Part 3A Concept Plan Application
Traffic and Transport

SIMTA Moorebank Intermodal Terminal Proposal

Paramics (Traffic) Model Audit

29 July 2011

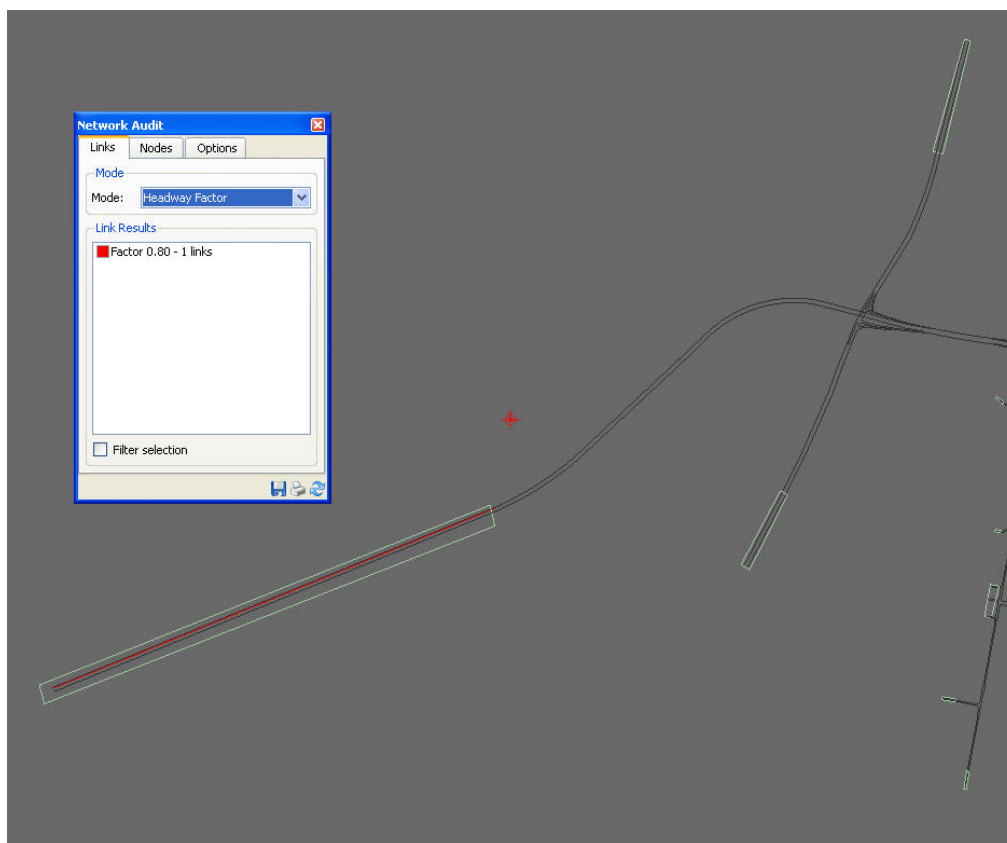
The eastbound off-ramp from M5 into Moorebank Avenue northbound is signal controlled according to our information. However, in the models this movement appears to be operating under free flow condition.

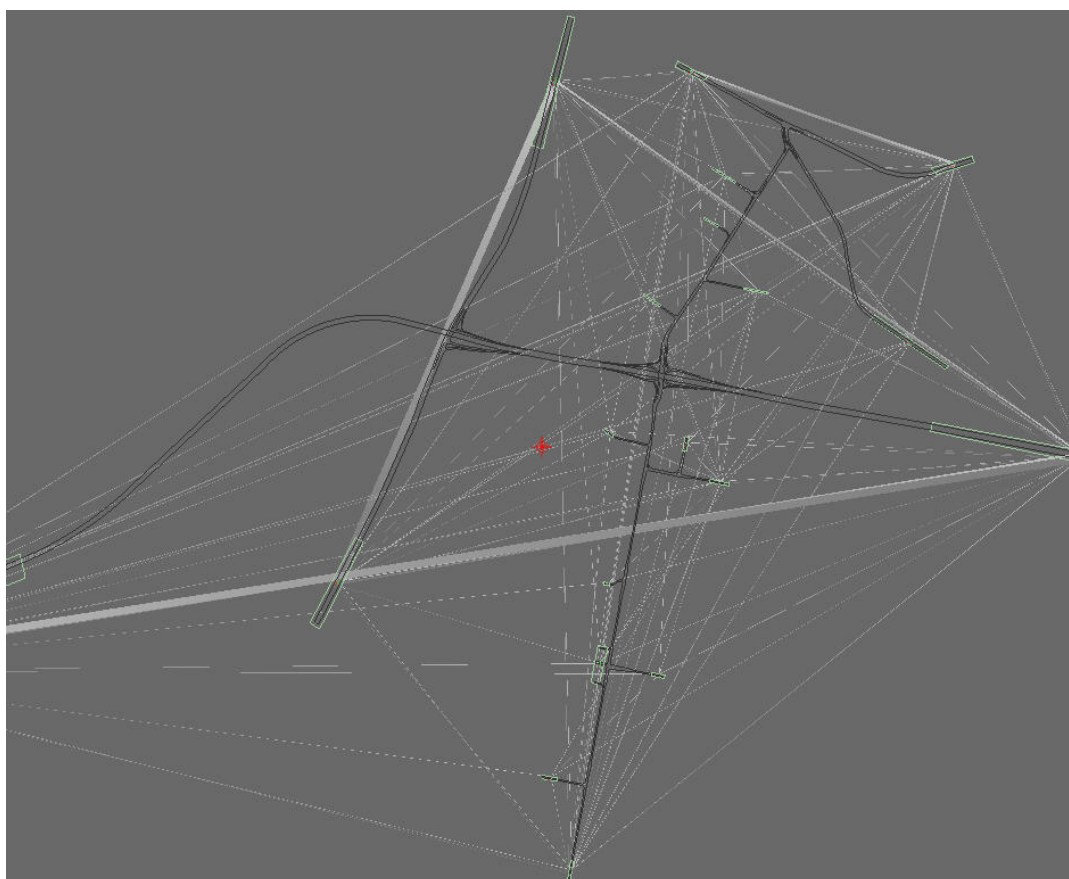
Reaction factors have been adjusted to 0.80 in the PM base model only on links at the east approach of Moorebank/Newbridge intersection. This is perceived as acceptable given the expected increase of driver aggressiveness under congested traffic conditions.
